# Tampa Electric Company (TECO)
# Coal Yard Assessment
## Stantec Job No. 198800347

September 2010
Revision 2

Stantec has been retained by Tampa Electric Company to provide a review of the coal field equipment at the Big Bend facility. The review scope boundaries are from the dock through conveyors L1 and L2 that bring the coal to the tripper deck in the power house.

C-35
C-20
C-21
C-19
C-32
C-33
C-34
C-26
C-22
C-30
C-31
C-25
C-27
C-28
C-23
C-24
C-36
BOTTOM CHORD PLAN
ROOF PLAN.
DETAIL "J"
SECTION BC-BC
SECTION BD-BD
2 TON MONORAIL (FUTURE)
2 TON MONORAIL

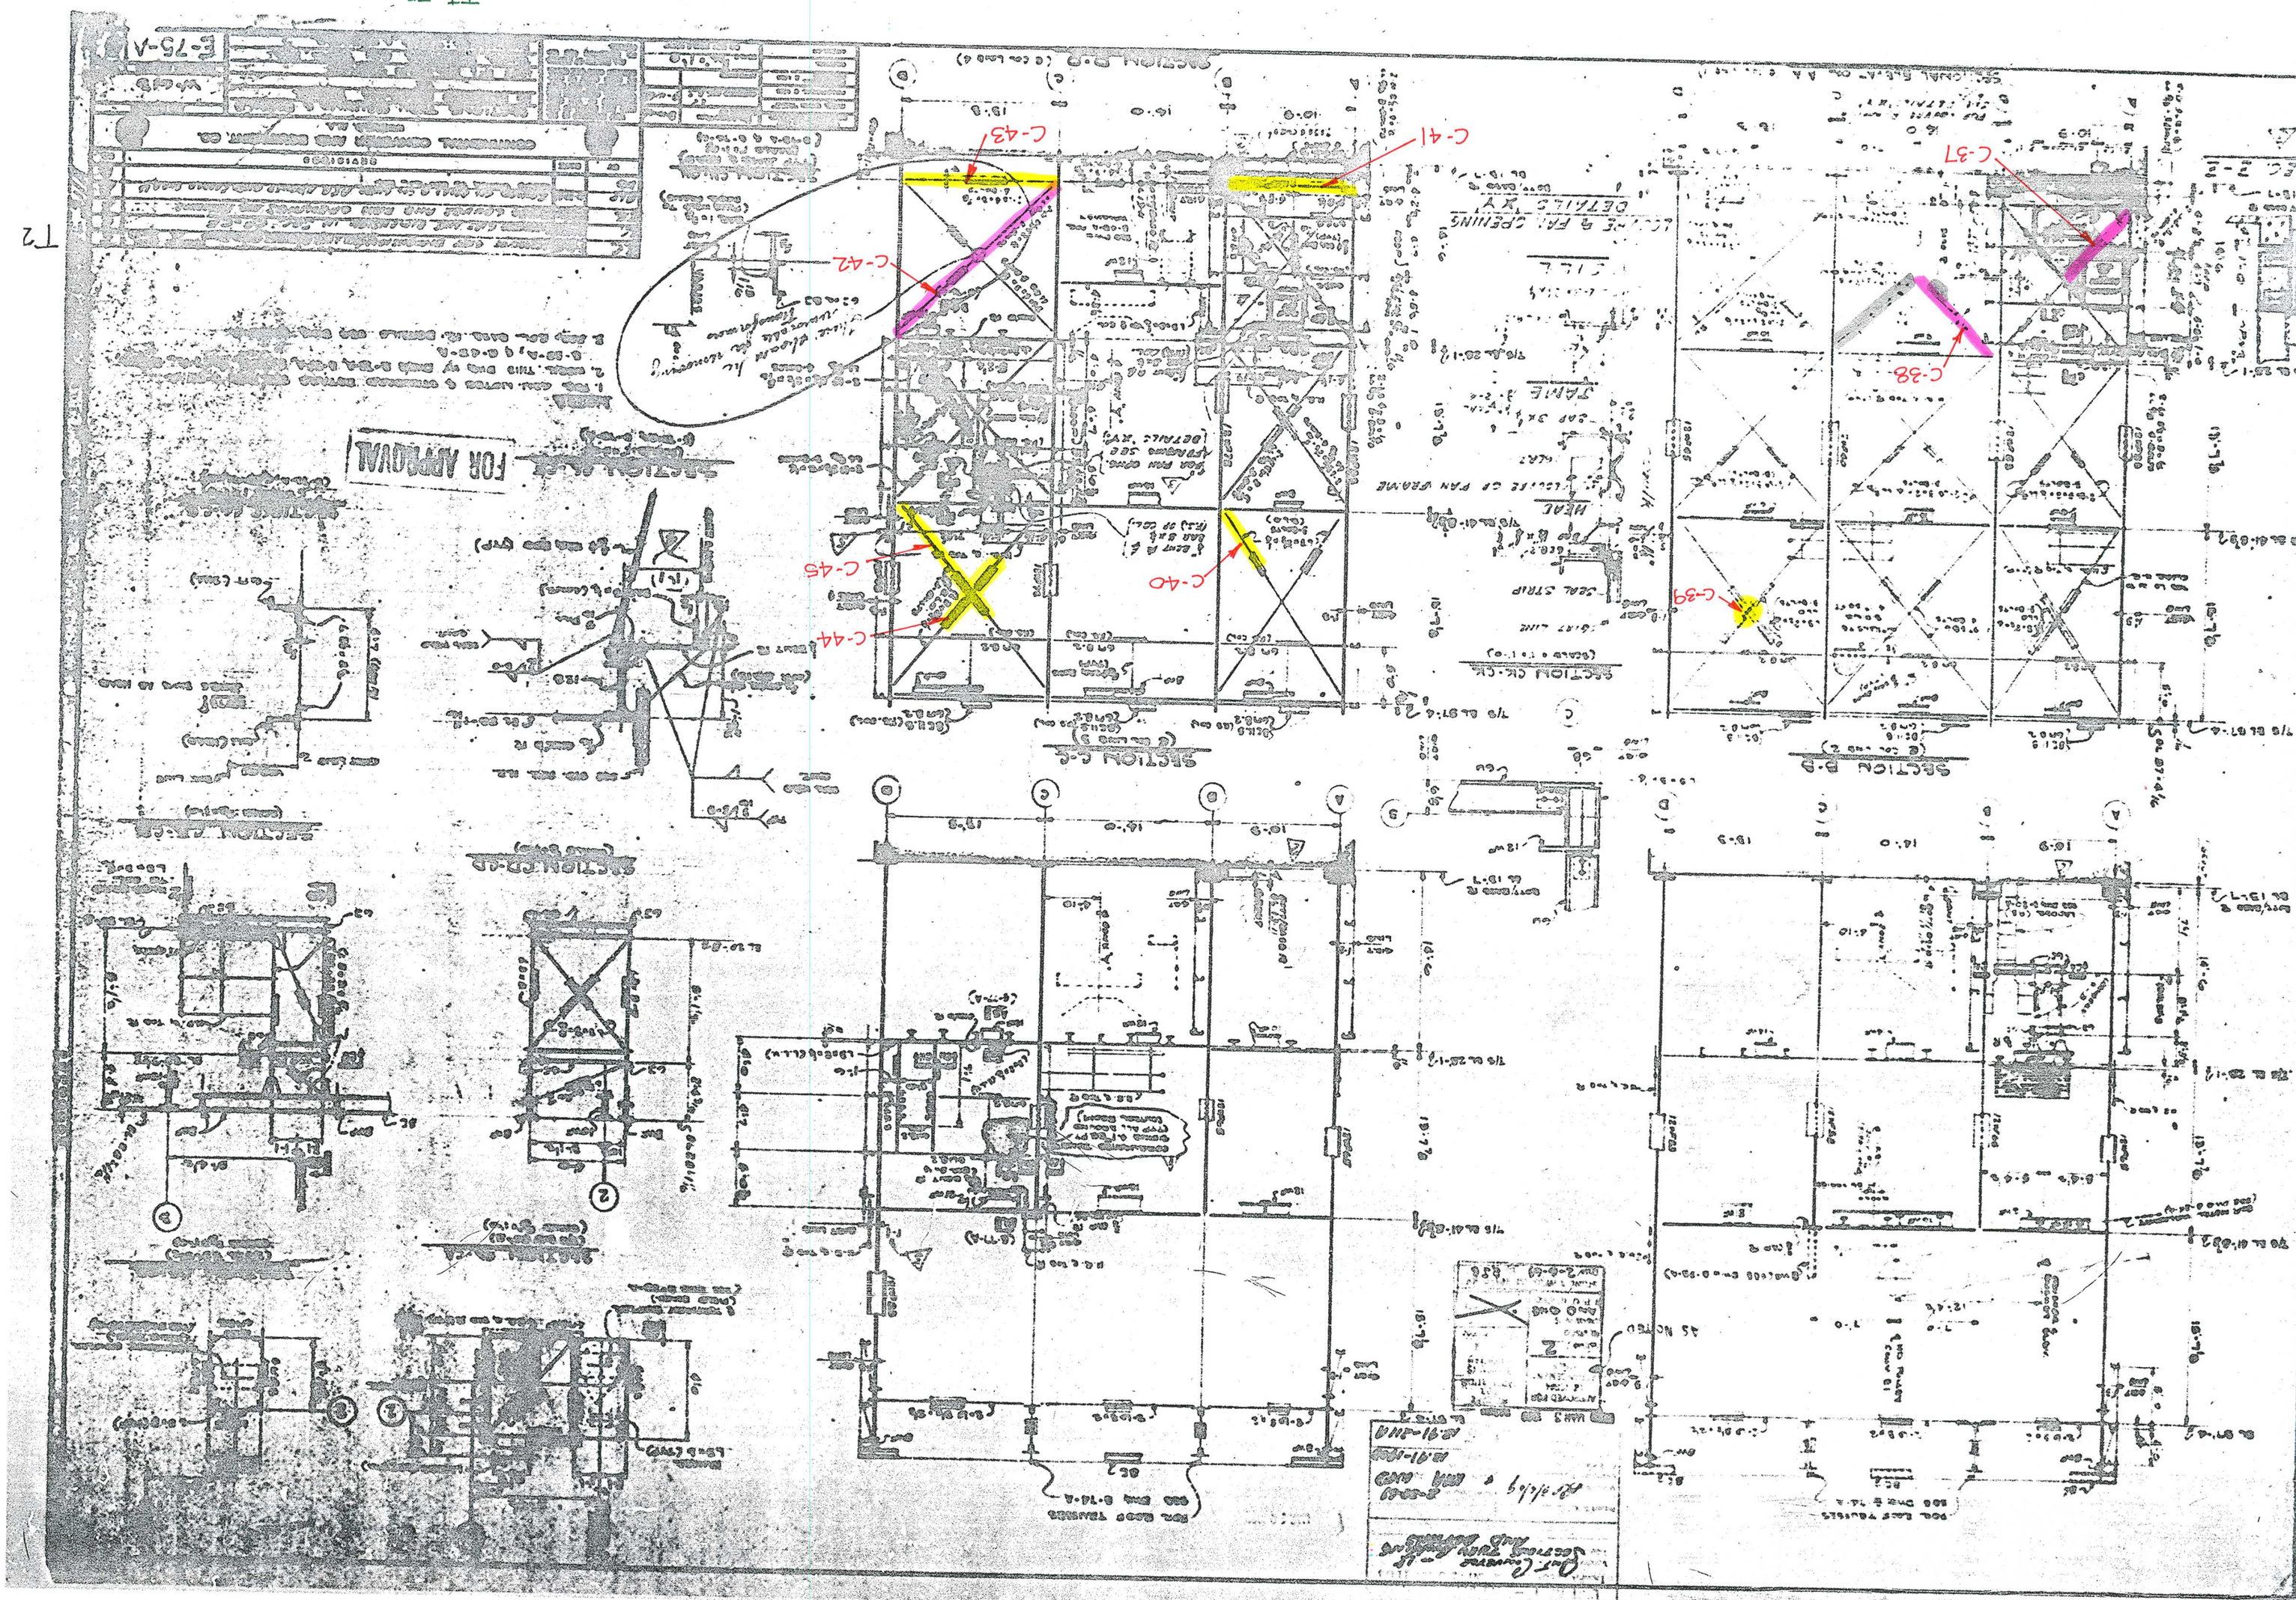
C-42 Connection of vertical brace to gusset plate has broken free and brace is no longer taking load. Recommend replacing gusset plant and field welding existing braces to new gusset plate. See included photo TTWR-T2-L.

| C-51 | Vertical bracing has moderate corrosion between the angles. Recommend cleaning and painting to prevent further damage. |
| C-52 & 53 | Vertical bracing has moderate corrosion between the angles and at gusset plate. Recommend cleaning and painting to prevent further damage. |

PICTURE CONV-F1-J

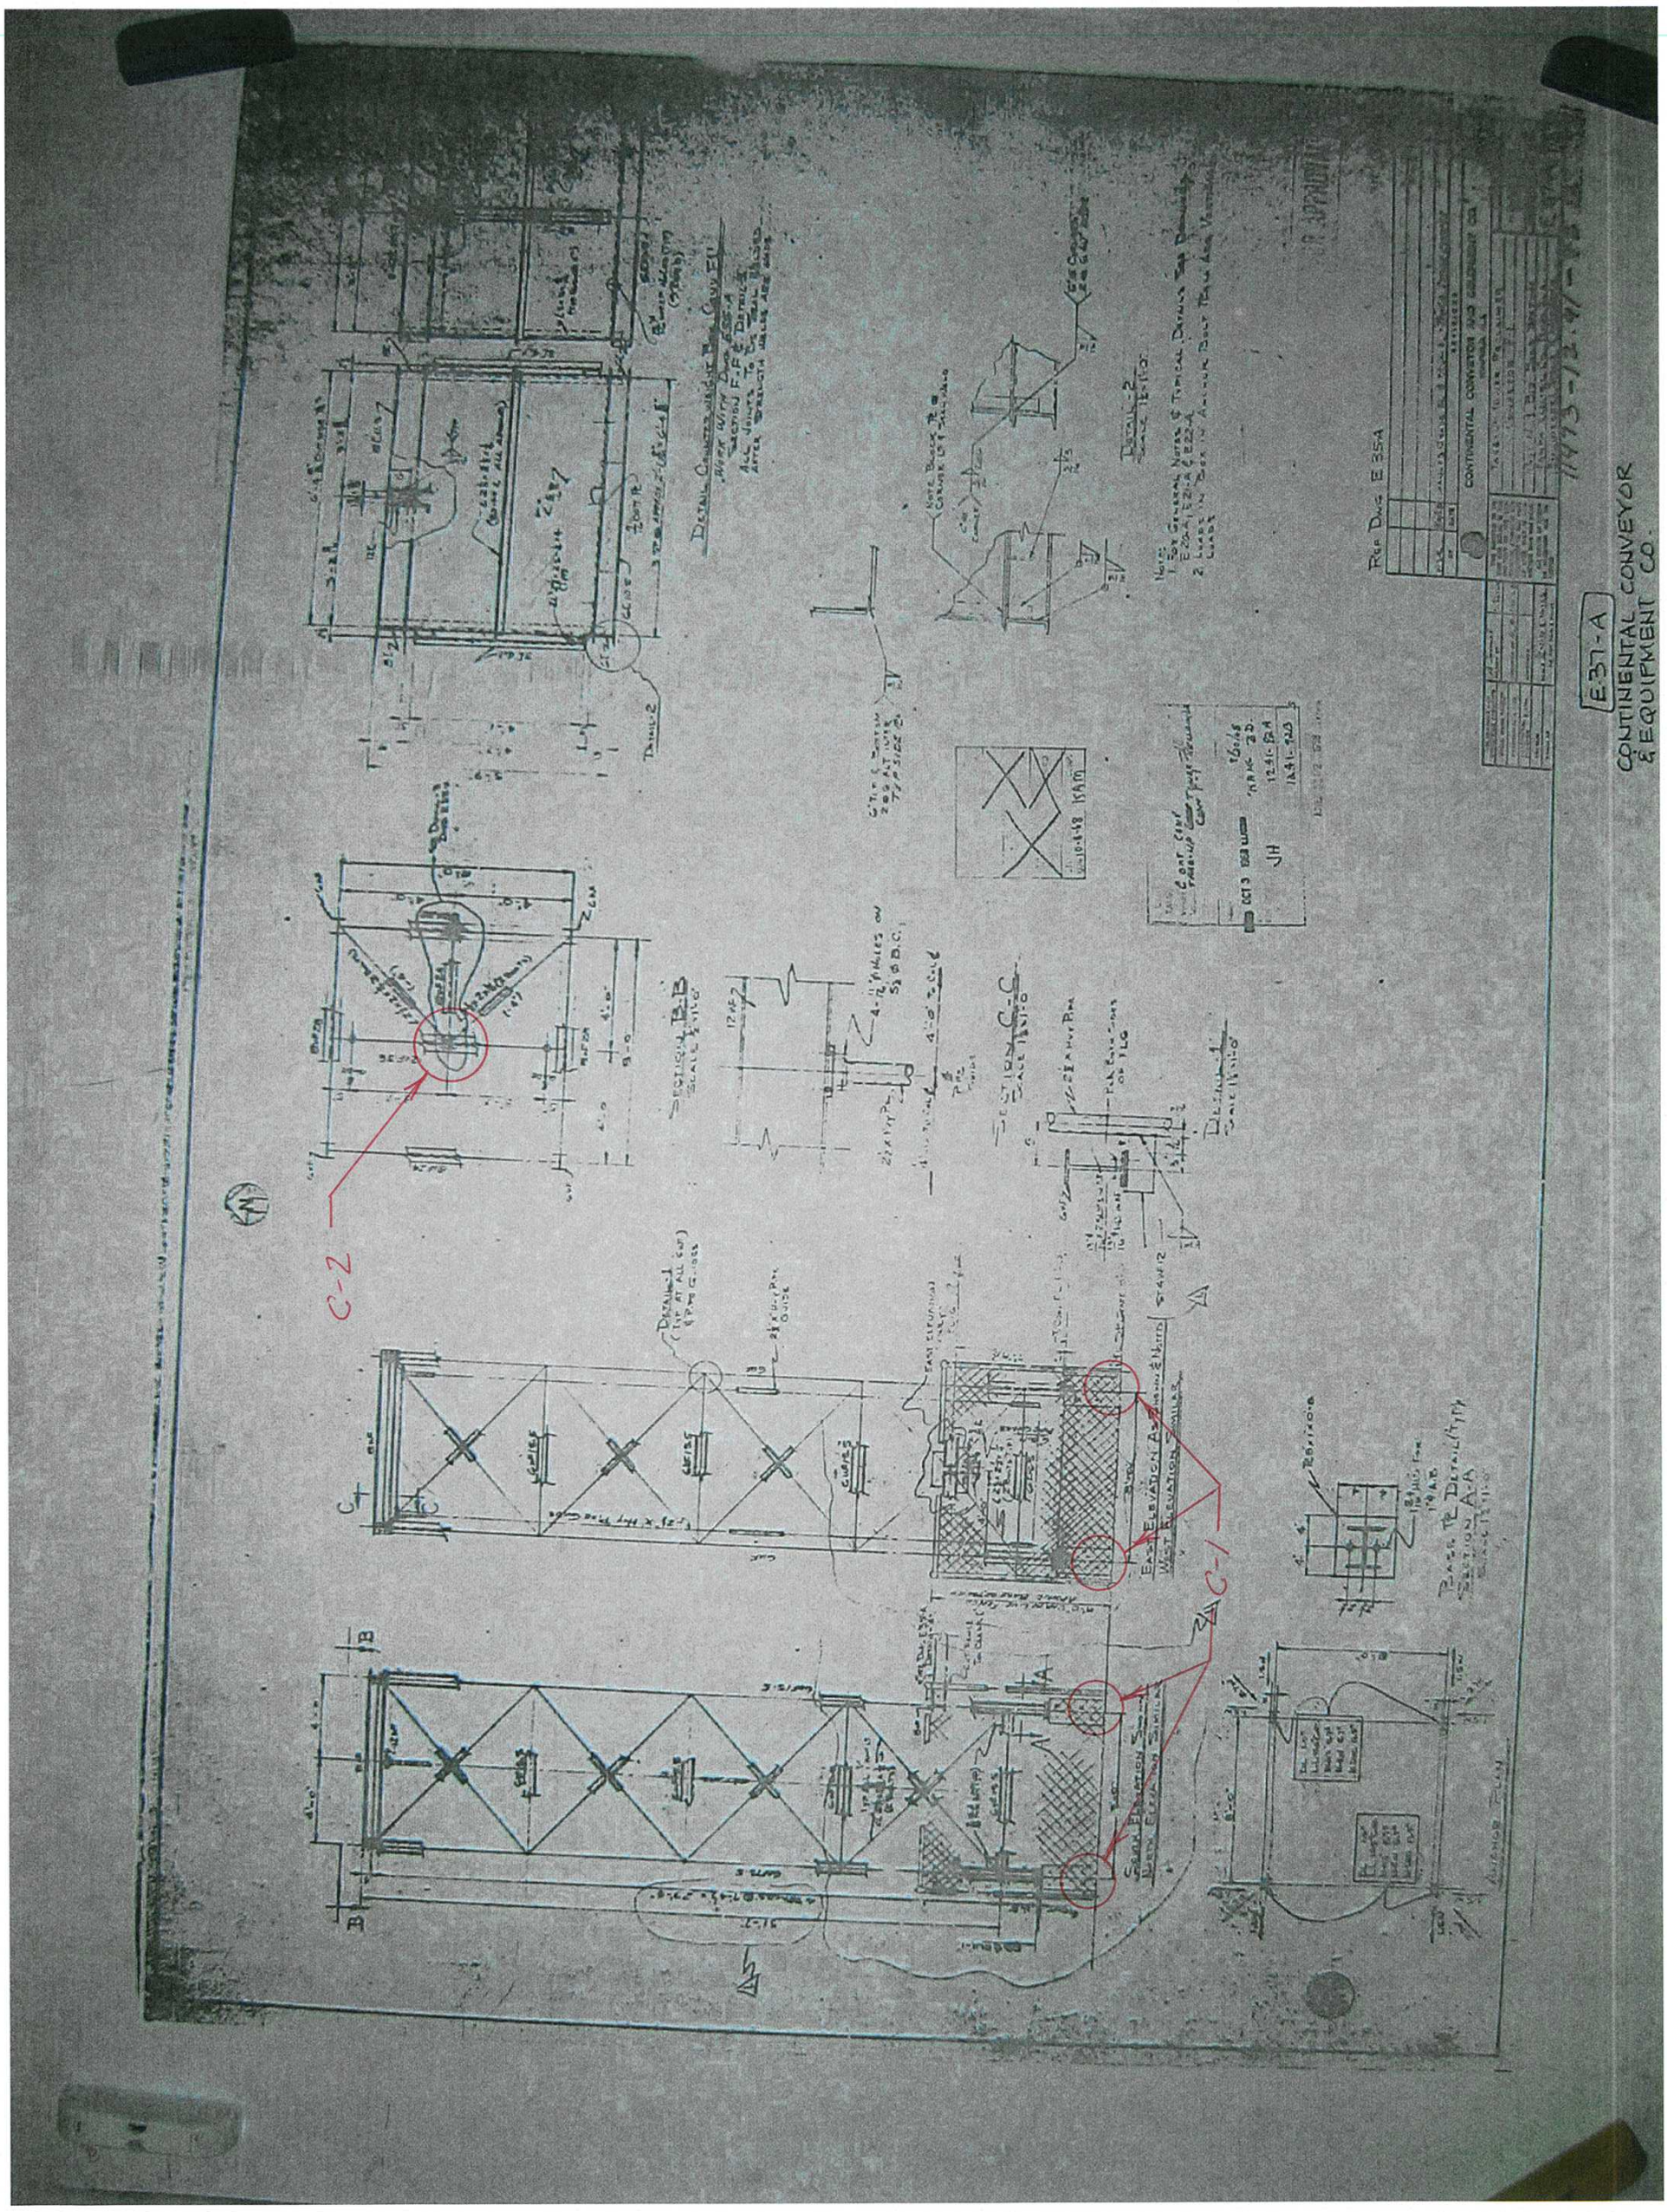
C-2 The framework supporting the horizontal pulley for the Conveyor F1 Take-up is extremely corroded as seen in Pictures CONV-F1-J and CONV-F1-K. This framing will need cleaning and paint, at the least, and possibly repairs if cleaning back to solid metal exposes significant loss of section of the members.
